Pavilion H Infusion Center Relocation

ADDENDUM # 1

10/31/2024

Purpose Addendum #1

2 GROUND FLOOR PLUMBING NEW WORK PLAN
P200 1/4" = 1'-0"

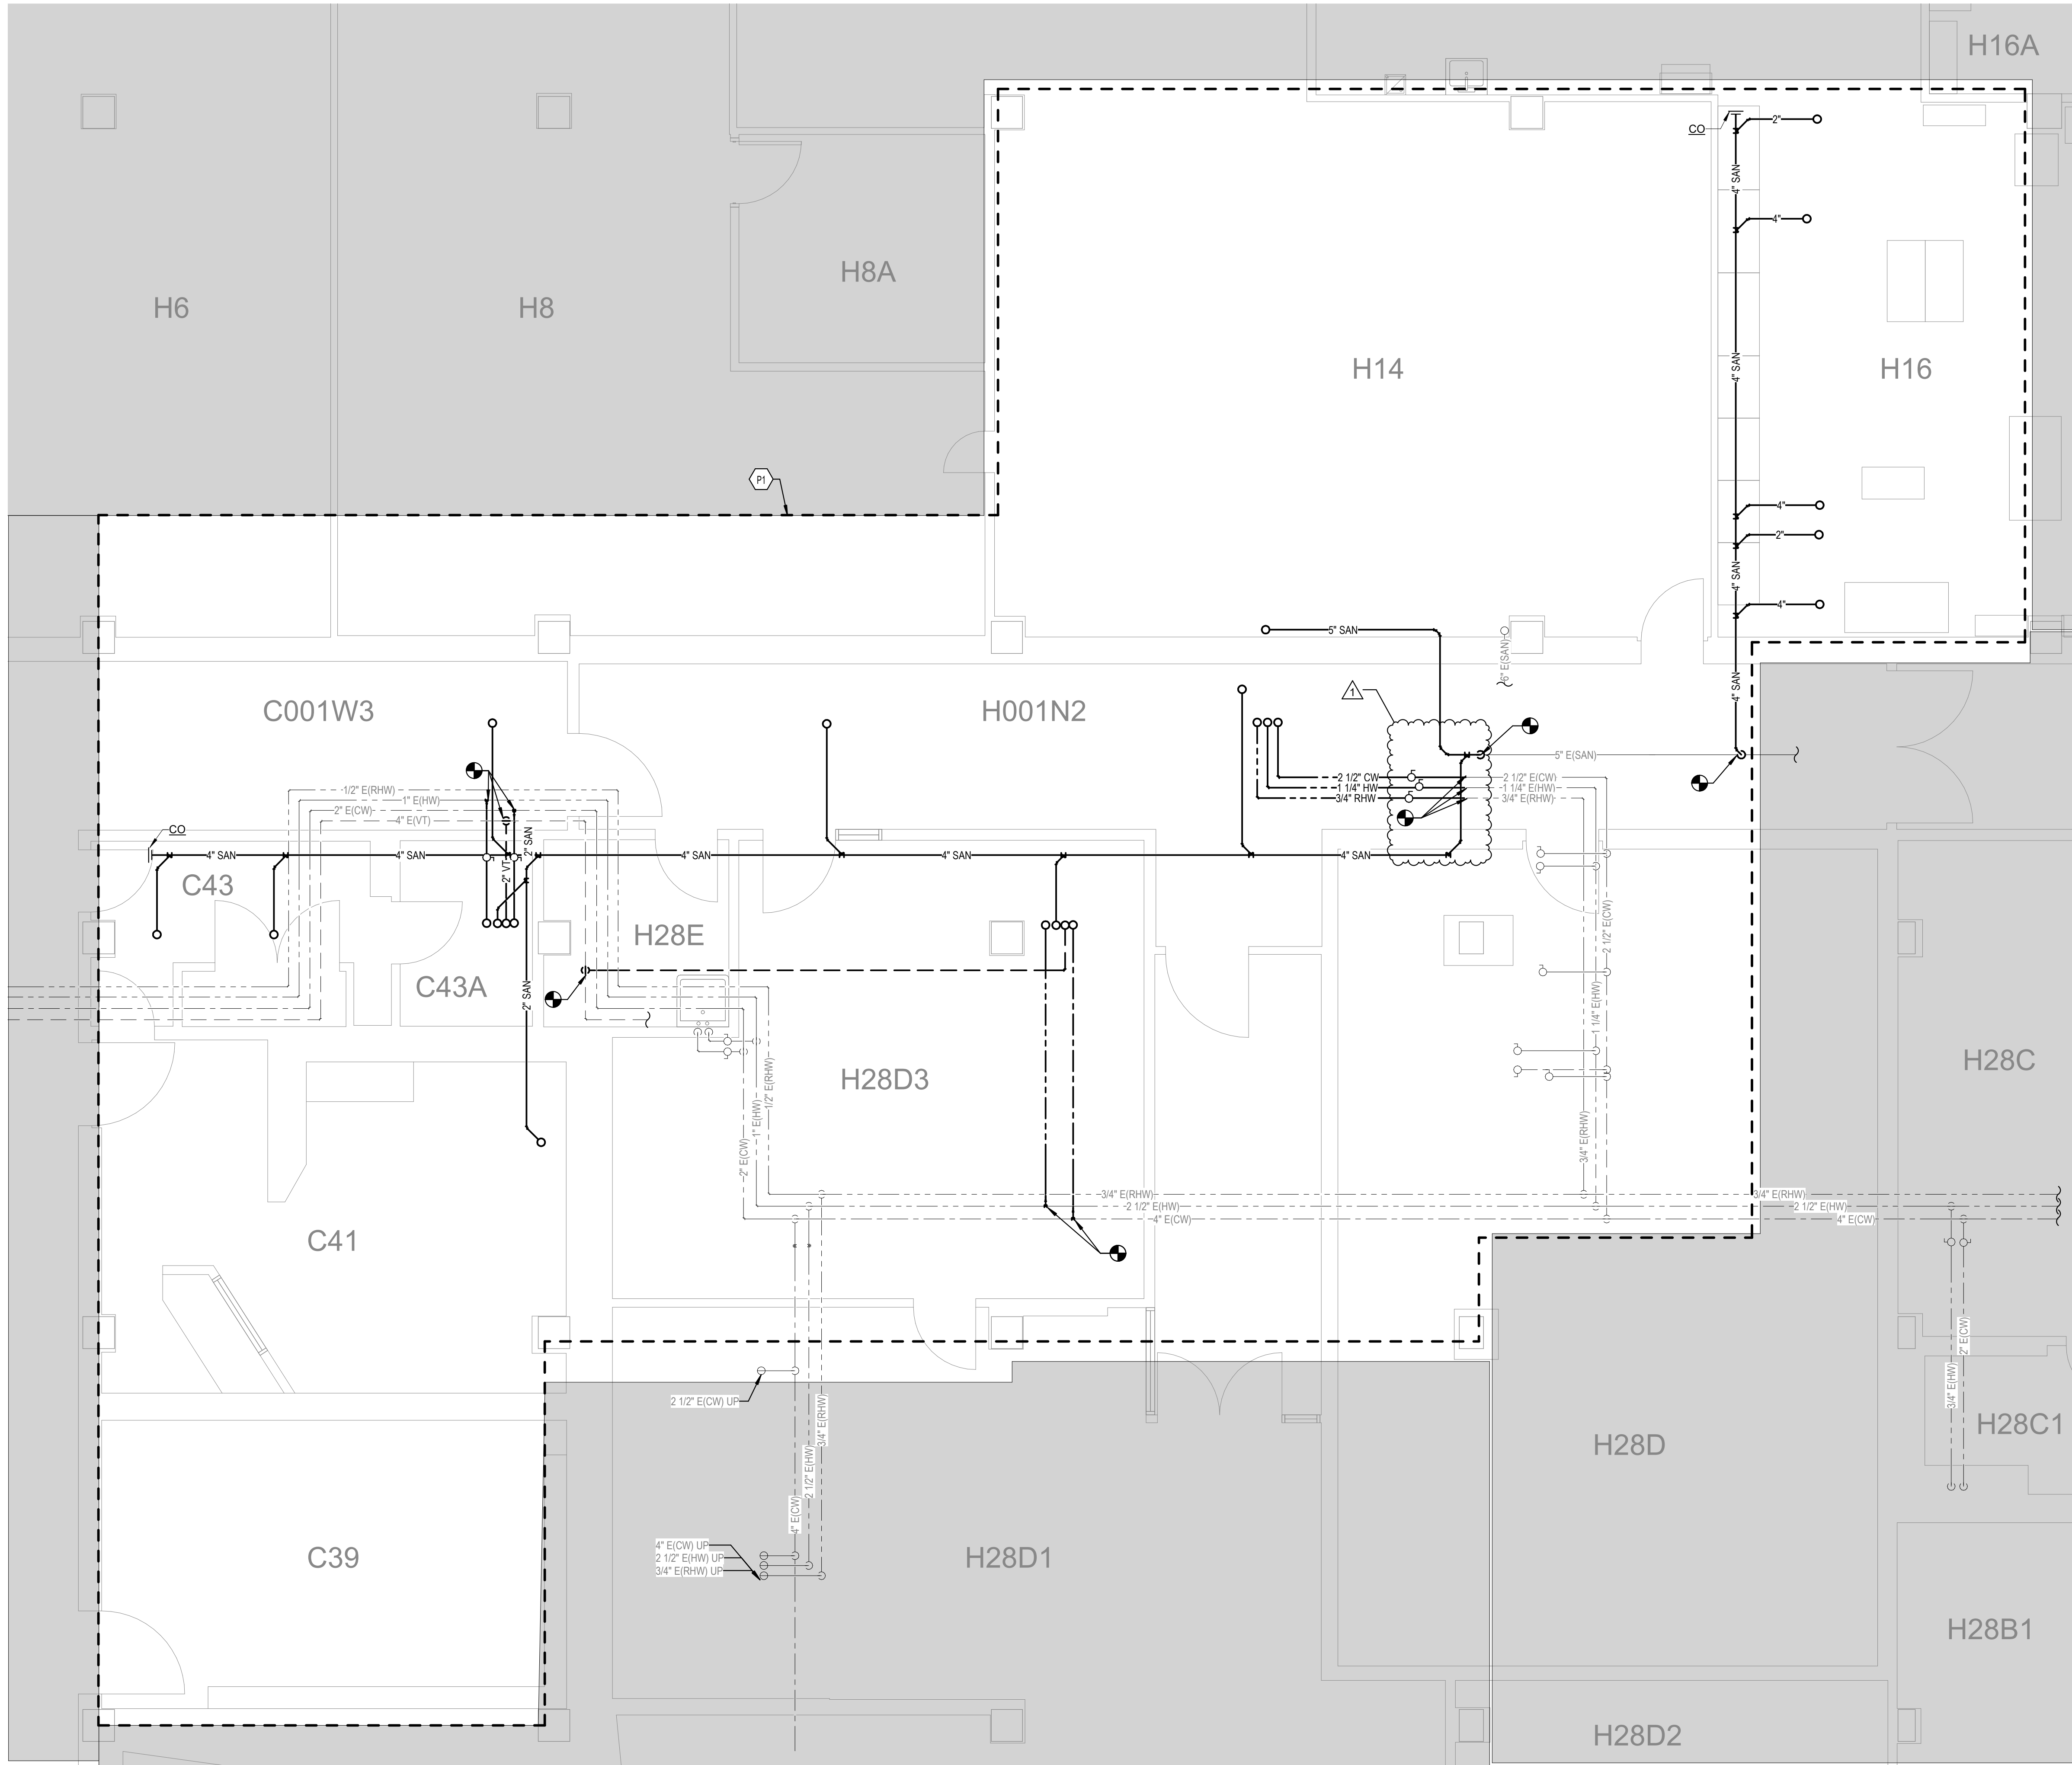
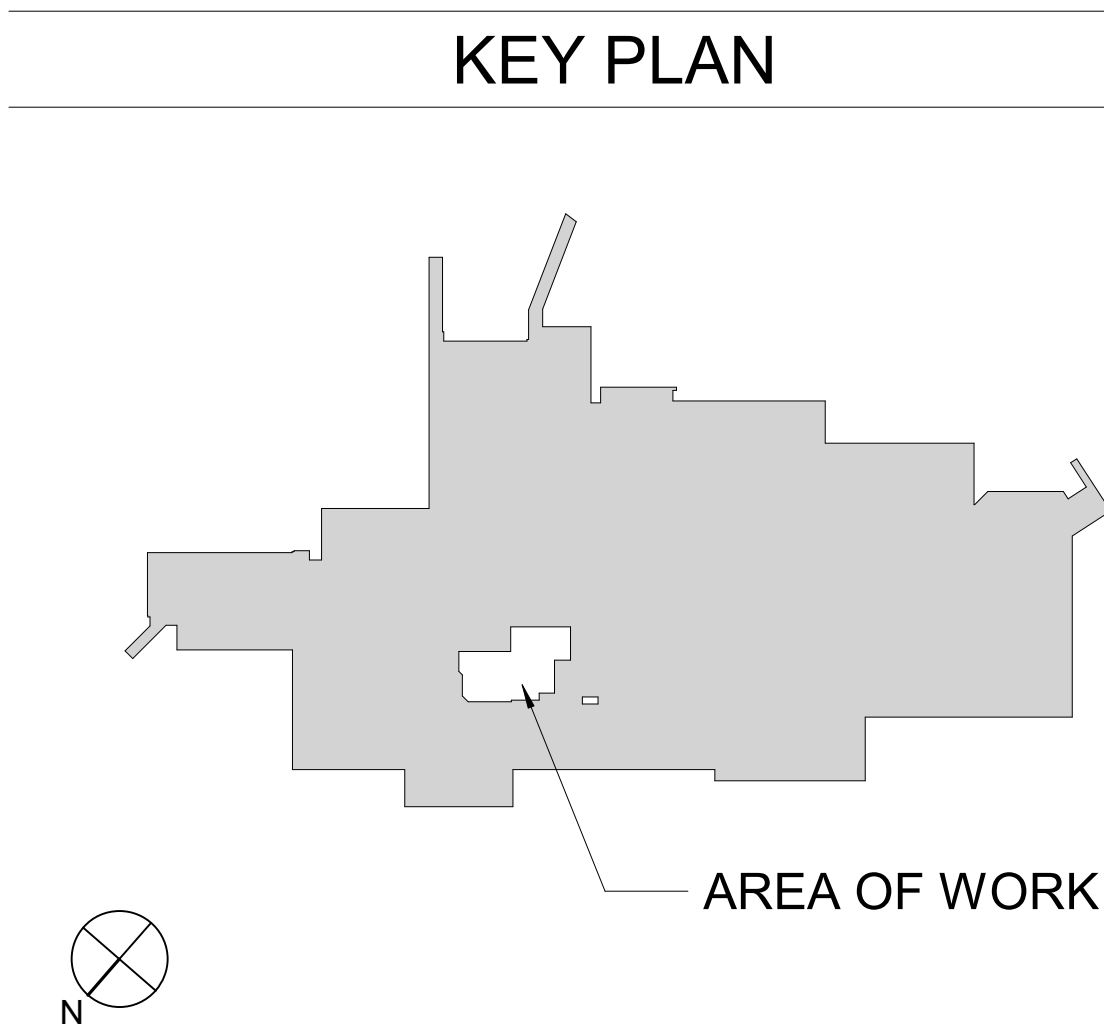
Item #4 Refer to the Mechanical Sheets P200 Ground Floor Plumbing New Work Plan

- A. Revised sanitary piping. Refer to attached drawing.

1 FIRST FLOOR HYDRONIC DEMOLITION PLAN
M102 1/4" = 1'-0"

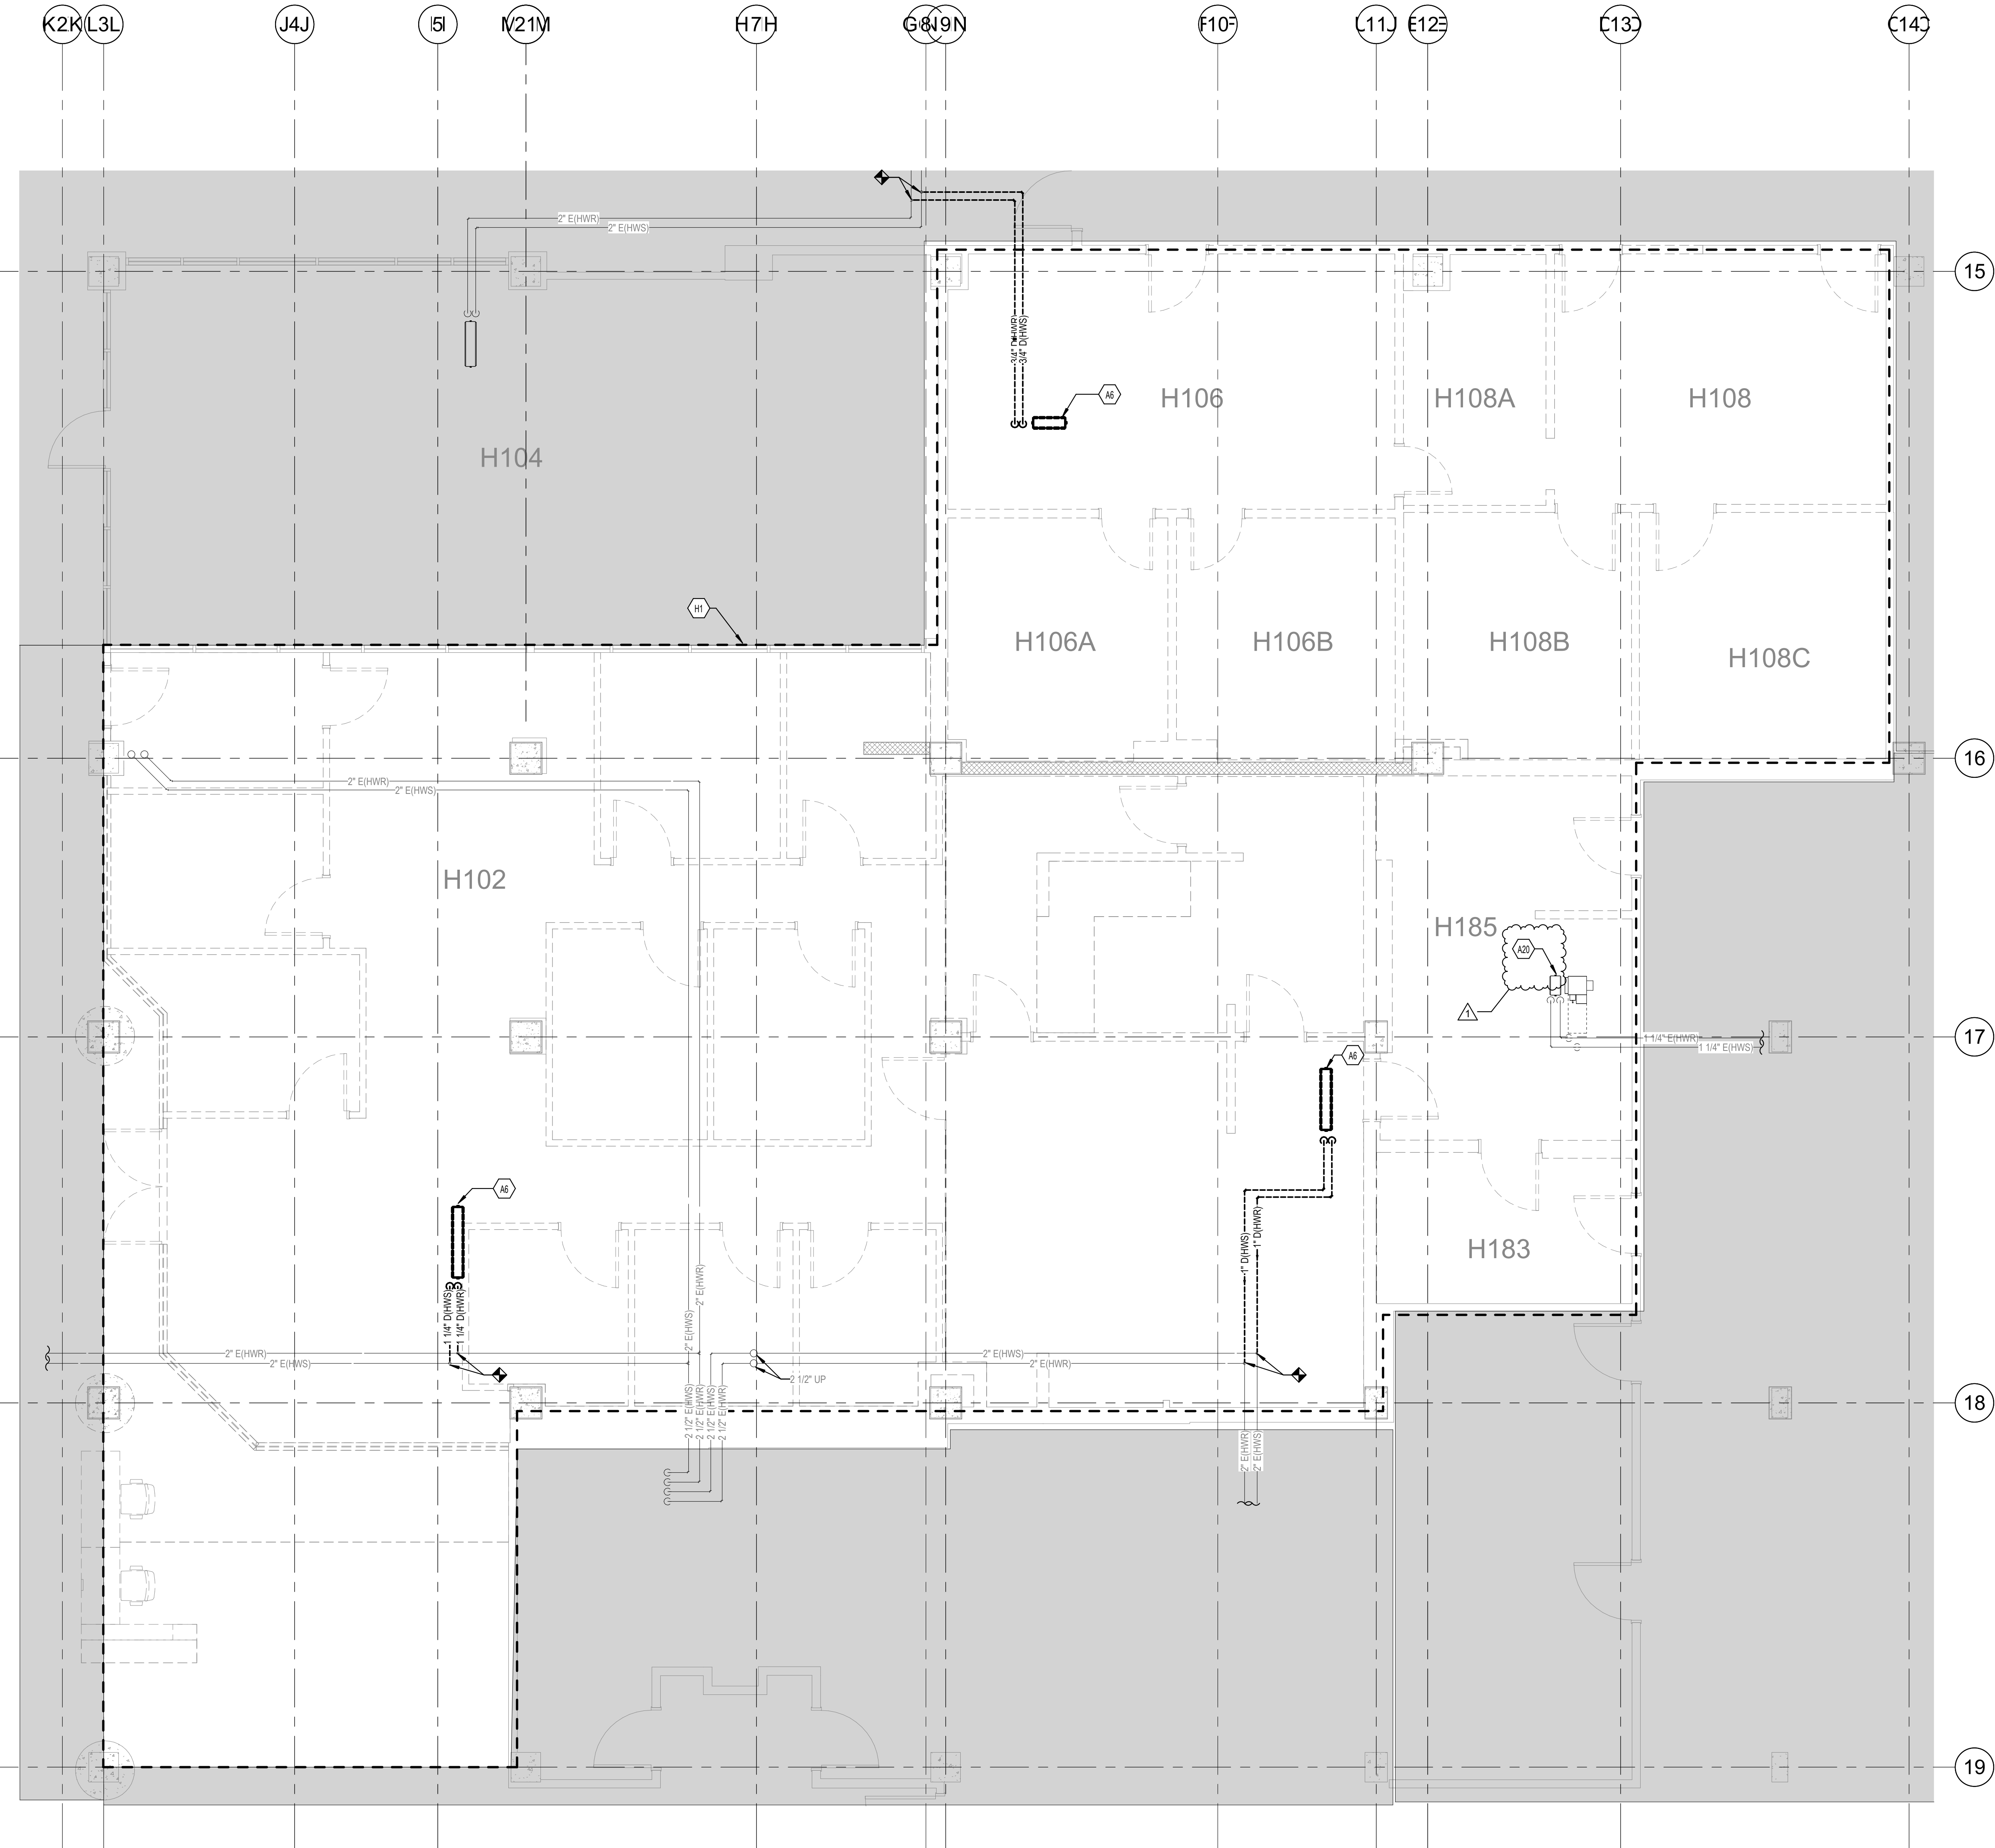
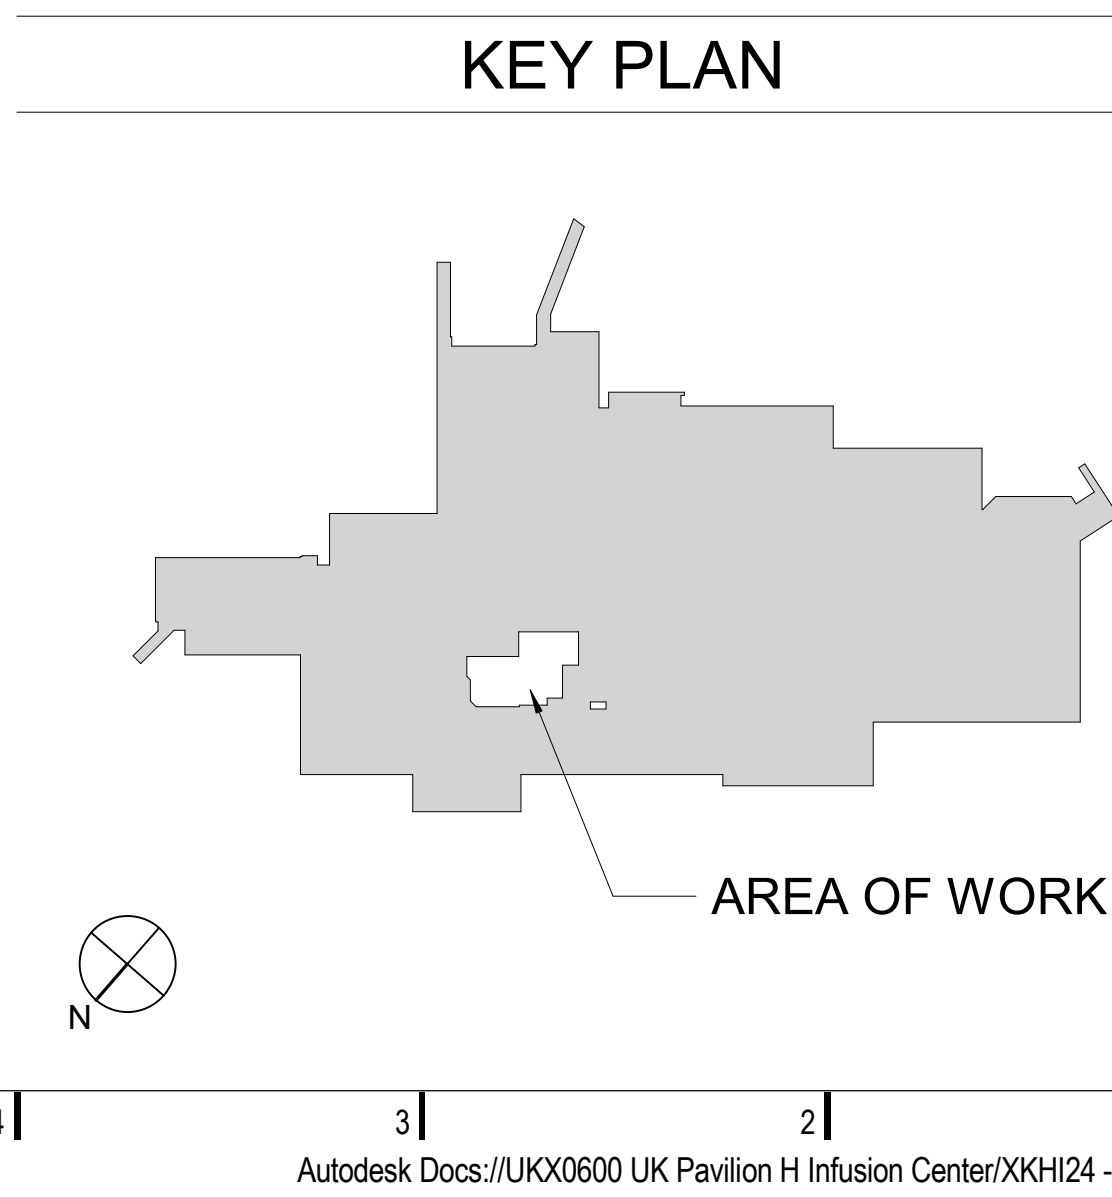
Item #3 Refer to the Mechanical Sheets M102 First Floor Hydronics Demolition Plan and M202 First Floor Hydronic New Work Plan

- A. Tagged Note A20 stating existing CAV and reheat coil to remain and be reused. Refer to attached drawing.

- TAGGED NOTES**
- A6 REMOVE REHEAT COIL AND ASSOCIATED SUPPORTS AND HANGERS
 - A20 EXISTING CAV AND REHEAT COIL TO REMAIN AND BE REUSED.
 - H1 PROJECT BOUNDARIES
